Access Compliance Report Public Rights-of-Way (Pedestrian Signals)

Intersection ID: N/A **Main Street:** Cross Street: N/A Location: N/A

Signal Type: One Push Button-APS Severity Score: BTN 1:N/A BTN 2: N/A No BTN: N/A ADA ID: A2C5F997F1B4 **Overall Compliance: No**

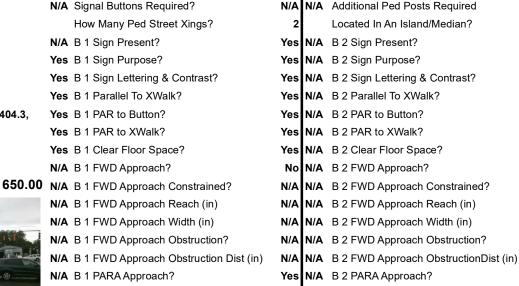
PROW/ADA: TMUTCD 4e.08, R404.2, R404.3, R404.7.3, R209.1, MUTCD 4e.10

N/A B 1 PARA Approach Width (in)	N/A	N/A	B 2 PARA Approach Width (in)	N/A	
					N/A B 1 PARA Approach Obstruction	n? Yes	N/A	B 2 PARA Approach Obstruction?	N/A
		N/A B 1 PARA Approach Obstruction	n Dist (in) 11.0	N/A	B 2 PARA Approach ObstructionDist (in)) N/A			
	Is Button 1 APS or Non-APS?	APS	Is Button 2 APS or Non-APS?	N/A	No B 1 Clear Floor Space Slope (9	%) 7.2	N/A	B 2 Clear Floor Space Slope (%)	N/A
Yes	B 1 VibroTact Arrow?	Yes	N/A B 2 VibroTact Arrow?	N/A	Yes B 1 Clear Floor Space XSlope	(%) 1.4	N/A	B 2 Clear Floor Space XSlope (%)	N/A
Yes	B 1 VibroTact Parallel to Xing?	Yes	N/A B 2 VibroTact Parallel to Xing?	N/A	N/A B 1 PAR Slope (%)	1.4	N/A	B 2 PAR Slope (%)	N/A
Yes	B 1 VibroTact Contrast	Yes	N/A B 2 VibroTact Contrast	N/A	Yes B 1 Height (in)	40.0	N/A	B 2 Height (in)	N/A
Yes	B 1 Pilot Light?	Yes	N/A B 2 Pilot Light?	N/A	Yes B 1 Pressure (#)	5.0	N/A	B 2 Pressure (#)	N/A
Yes	B 1 Pilot Light Illumination?	Yes	N/A B 2 Pilot Light Illumination?	N/A	Yes B 1 Closed Fist Operation?	Yes	N/A	B 2 Closed Fist Operation?	N/A

Possible Solutions: Replace Signal Push Button With APS Button on New Post. Remove & Relocate Sign.
